SB-10058864-7073**1 5 07-15****Service Information Bulletin**

SUBJECT	DATE
SPN 1590(CPC)(GHG14) and SPN 1590 (CPC)(EPA07;EPA10)	May 2015

Additions, Revisions, or Updates

Figure 1. GHG14 Adaptive Cruise Control

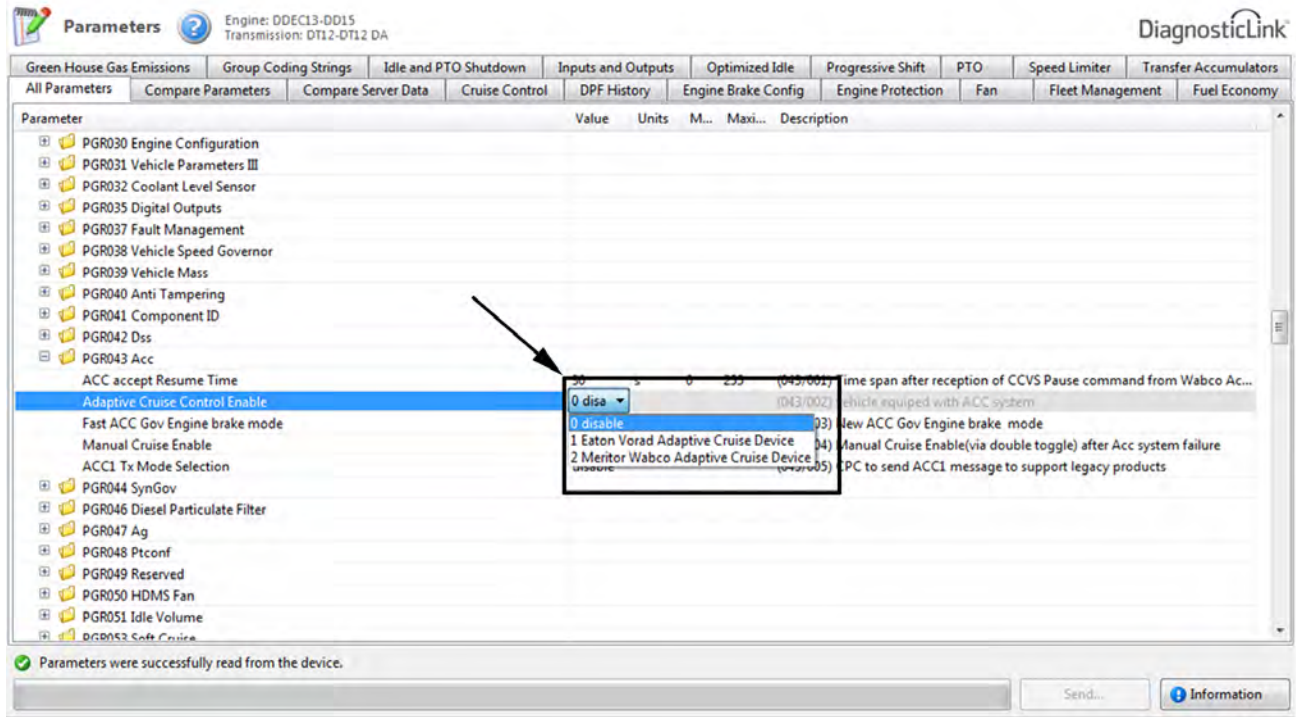
Publication Number / Title	Platform	Section Title	Change
DDC-SVC-MAN-0084 DDC-SVC-MAN-S084	DD Platform	SPN 1590/ FMI 9- GHG14	The diagnostic procedures have been separated and new information has been added to GHG14 for the Detroit Assurance option.
		SPN 1590/ FMI 9- EPA07 - EPA10

1. Connect DiagnosticLink[®].
2. Turn the ignition ON (key ON, engine OFF).
3. Verify that the vehicle is equipped with an adaptive cruise system. Is the vehicle equipped with adaptive cruise?
 - a. Yes; Go to step 5.
 - b. No; Go to step 4.
4. Verify that the "adaptive cruise control enable" parameter PGR043 is disabled; refer to the Application and Installation (A&I) manual. Is parameter PGR043 disabled?
 - a. Yes; replace the Common Powertrain Controller (CPC). Verify repair.
 - b. No; change the "adaptive cruise control enable" parameter PGR043 to disabled. Verify repair.
5. For vehicles equipped with Detroit Assurance, parameter PGR043 should be set to 0 (zero) disable. Is parameter PGR043 set to disable?
 - a. Yes; replace the CPC. Verify repair.
 - b. No; change parameter PGR043 to disable. Verify repair.
